Re: Tract N-1-B Watershed Subdivison - Sketch Plat Submittal

TRACTS N-1-B, WATERSHED SUBDIVISION zoned **PC**, located on **ARROYO VISTA** between **118TH ST** and **98TH ST** containing approximately 60.08 acre(s). (J-8)

REQUEST: Sketch Plat review for Tract N-1-B Watershed
IDO -2022

Development Facilitation Team (DFT) – Review Comments

PLAT OF
TRACTS N-1-A & N-1-B
WATERSHED SUBDIVISION
(A REPLAT OF TRACT N-1,
WATERSHED SUBDIVISION)
PROJECTED SECTIONS 17 AND 18,
TOWNSHIP 10 NORTH, RANGE 2 EAST,
N.M.P.M.
ALBUQUERQUE,
BERNALILLO COUNTY, NEW MEXICO
AUGUST, 2023

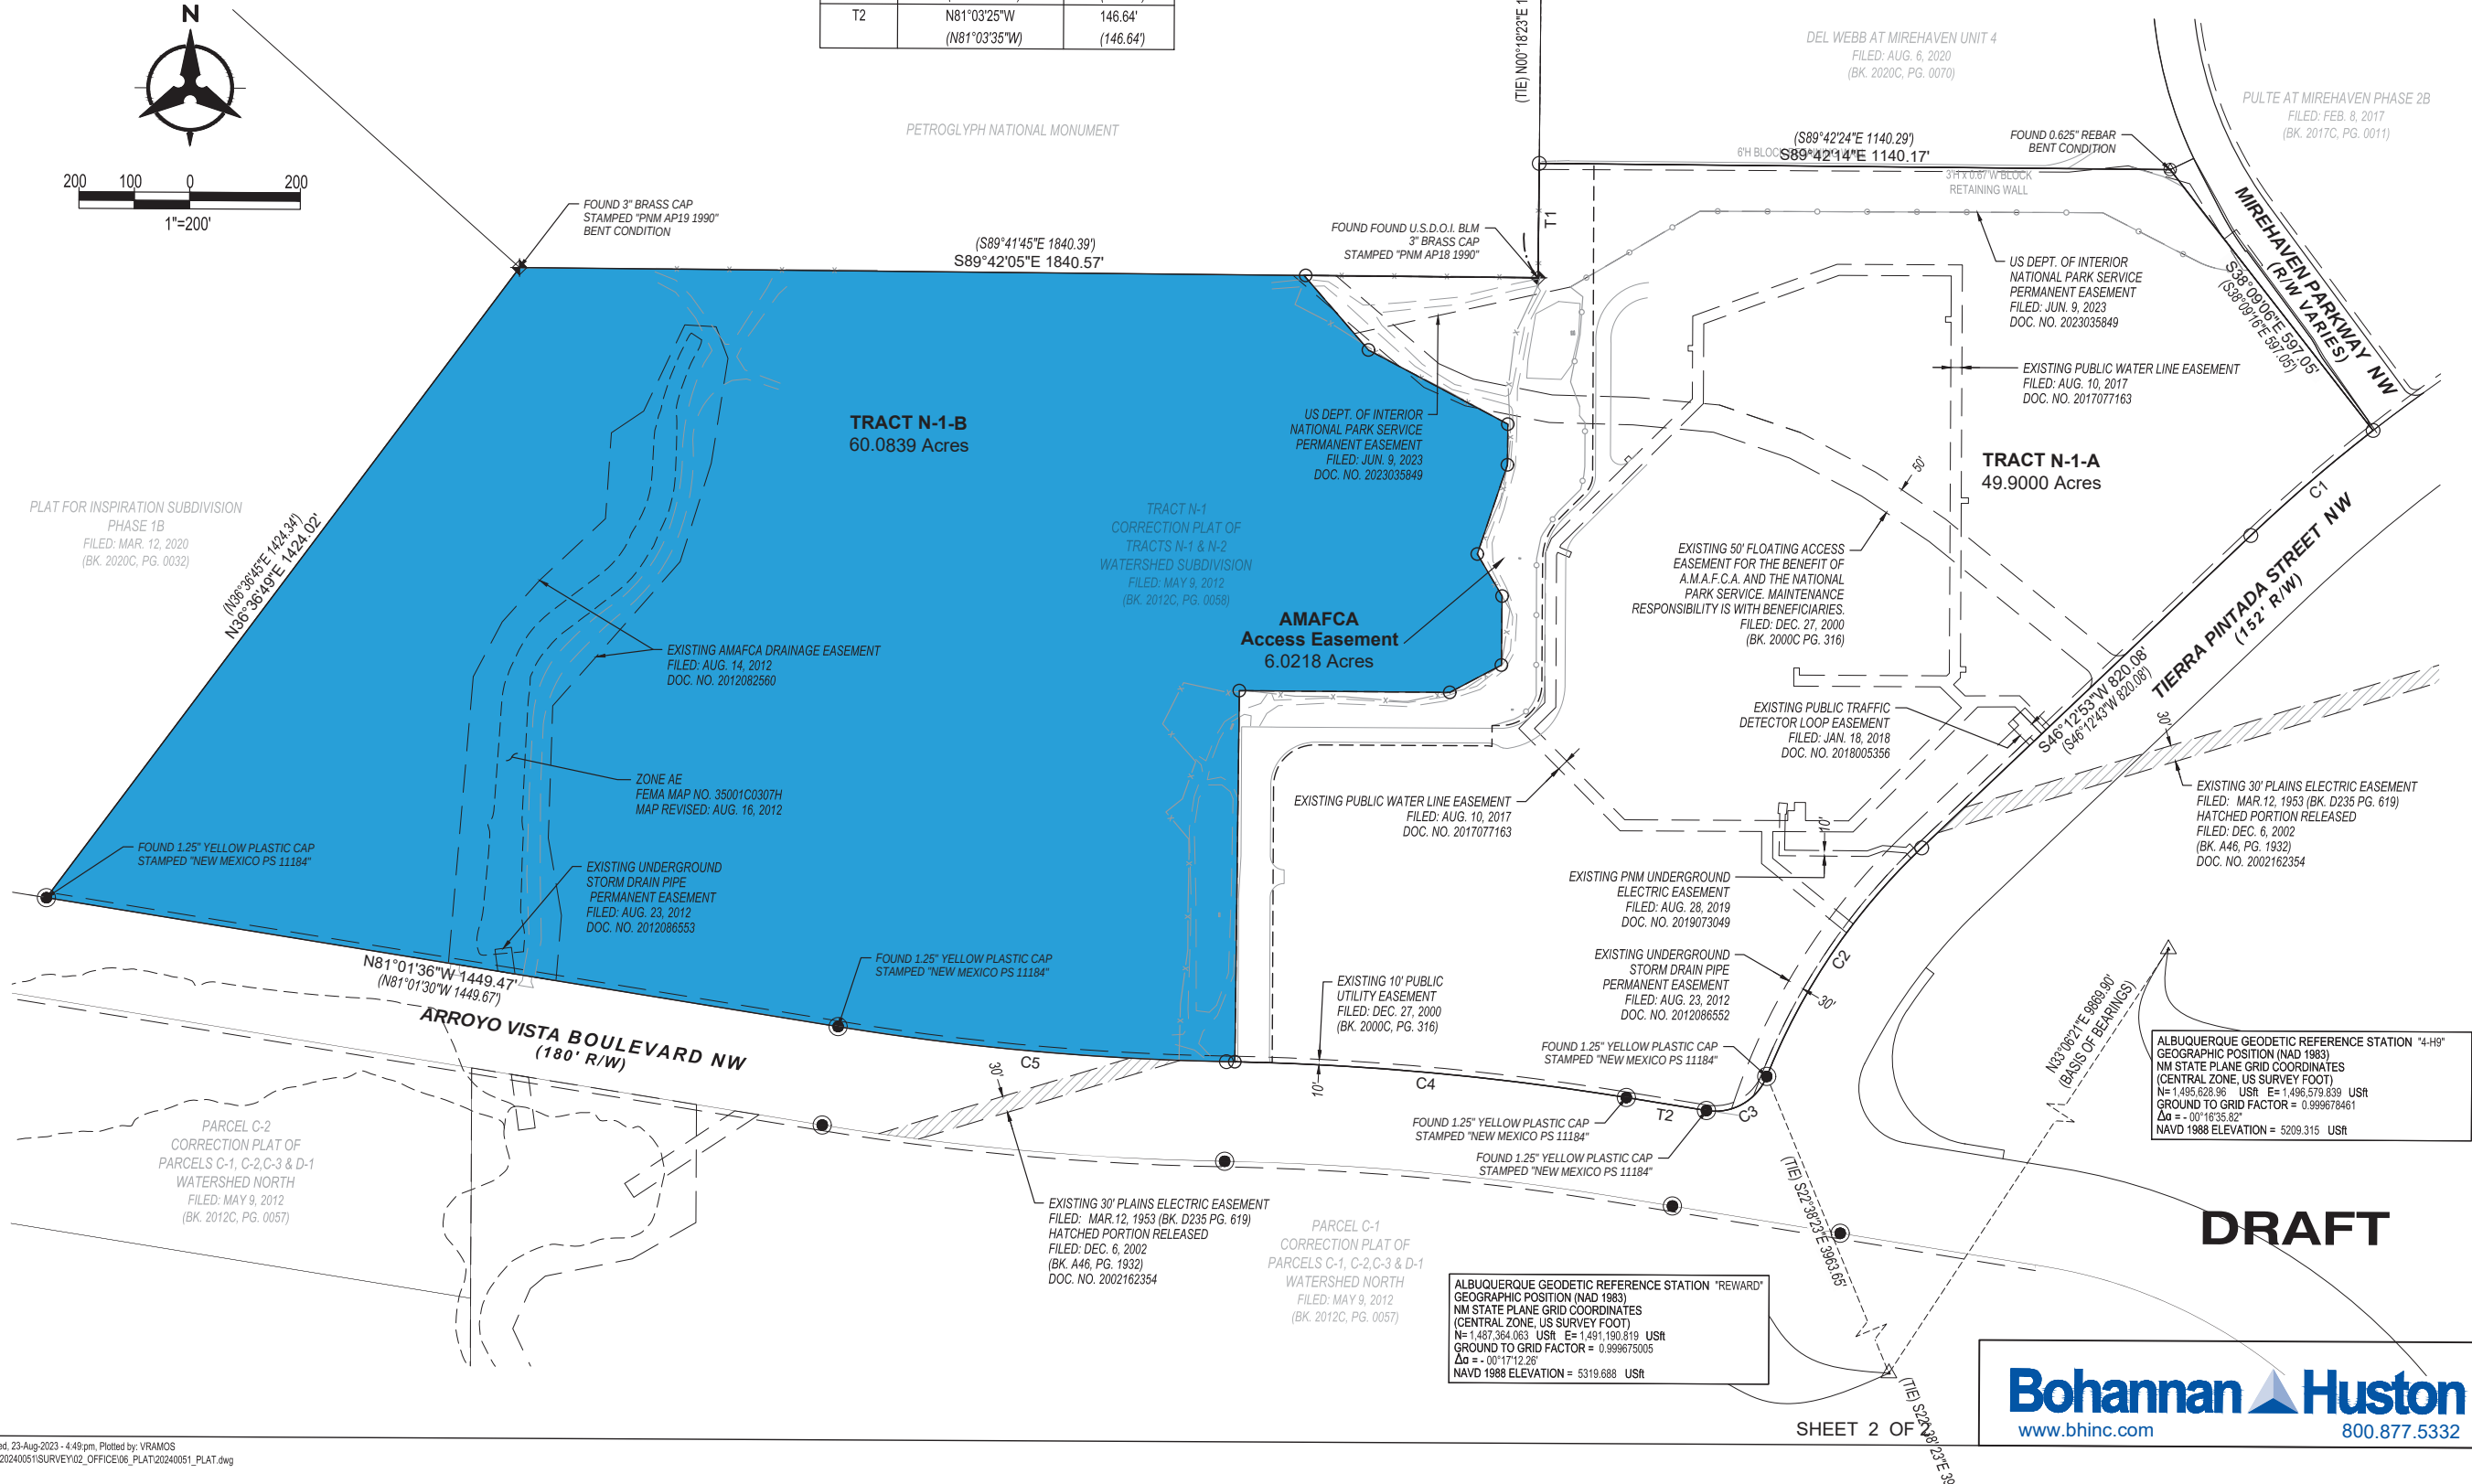
- A previous sketch plat was reviewed April 17, 2024. That Sketch Plat review request was for a Bulk Land Plat, subdividing an existing tract, Tract N-1 of the Watershed subdivision, into Tract N-1-B at 60.0839-acres in size and Tract N-1-A at 49.9-acres in size. **Tract N-1-A and Tract N-1-B still need to be created. Tract N-1-B could then be further subdivided.**

- Platting applications would be subject to review and approval by the City of Albuquerque/Development Hearing Officer (DHO). residential would be >>>>>
- The western tract (proposed Tract N-1-B in this sketch plat) is a proposed residential subdivision, and not an educational land use. The parcel is subject to the requirements of the Westland Framework Plan and the IDO and DPM where the Framework Plan is silent. As the Westland Framework Plan depicts the subject property as an Education land use, any other future land uses on the site requires an amendment of the Westland Framework Plan, requiring EPC or City Council approval of the amendment. DRS Planning staff advises the applicant to schedule a PRT meeting with UDD staff regarding this step.

- A Bulk Land Plat application could be acceptable to transfer Tract N-1-B to another owner.
- The site area meets the minimum lot size requirements for a Bulk Land Plat per 6-6-6(J(1)(b)(2) of the IDO.

It is noted that a single-loaded street has been placed on the edge of the subdivision adjacent to Petroglyph National Monument which meets of the requirements of 5-2(J).

It would appear that you have been able to keep some block lengths under 600 feet, but some are not.

File: 24-Jun-2024 - 11:24am, Project by: SS, BHI
P:\2404057\2404057\Drawings\2404057_Conceptual Utility.dwg

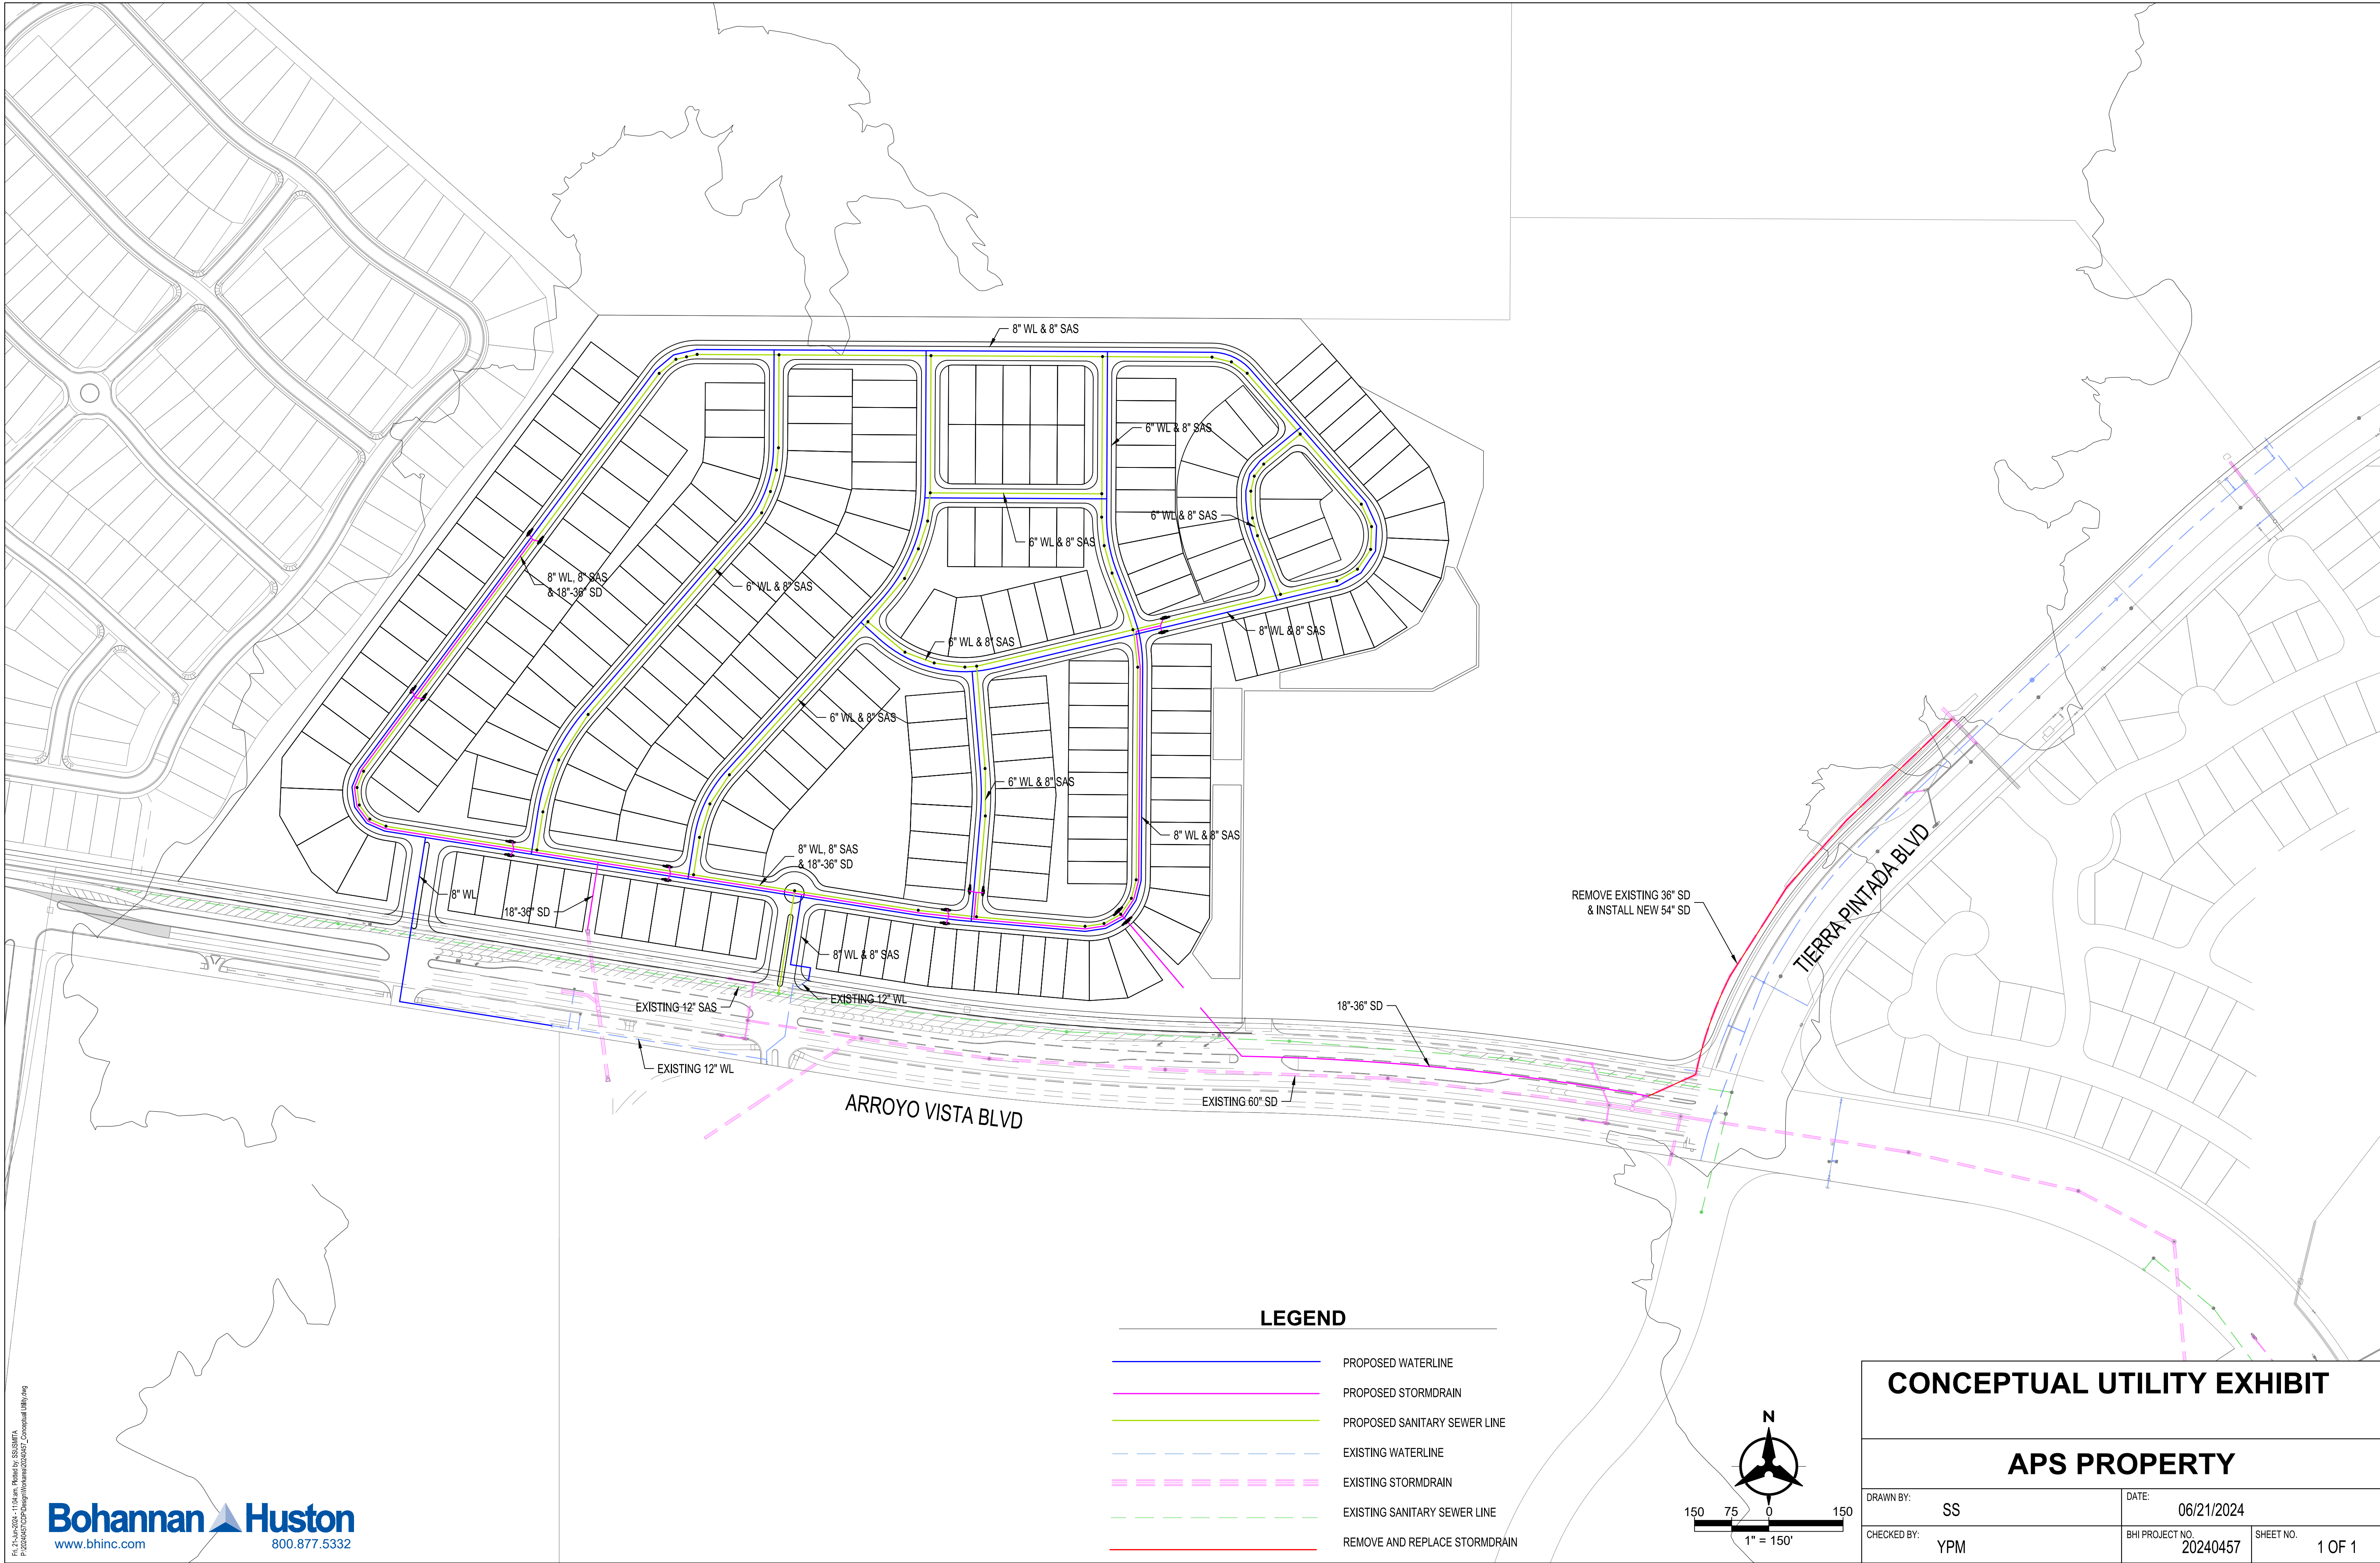
1. Request an availability/serviceability statement online at the following link:
http://www.abcwua.org/Availability_Statements.aspx. Requests shall include fire marshal requirements. An executed statement must be obtained prior to approval.
2. Regarding the comment for water, please provide a maximum pad elevation for the site to determine if there is any need for 5W infrastructure.
 - a. Note that the highest contour I see for the site based on our mapping system is right at the 5W/4W pressure zone boundary at 5485 feet which is evident the entire site currently sits within the 4W pressure zone thus not requiring a PRV to provide pressure to the site.
3. As proposed the site is on a really long dead end line and will require some sort of loop. Perhaps to the adjacent site on APS site which will create a good looped water system to provide redundancy for the future development.
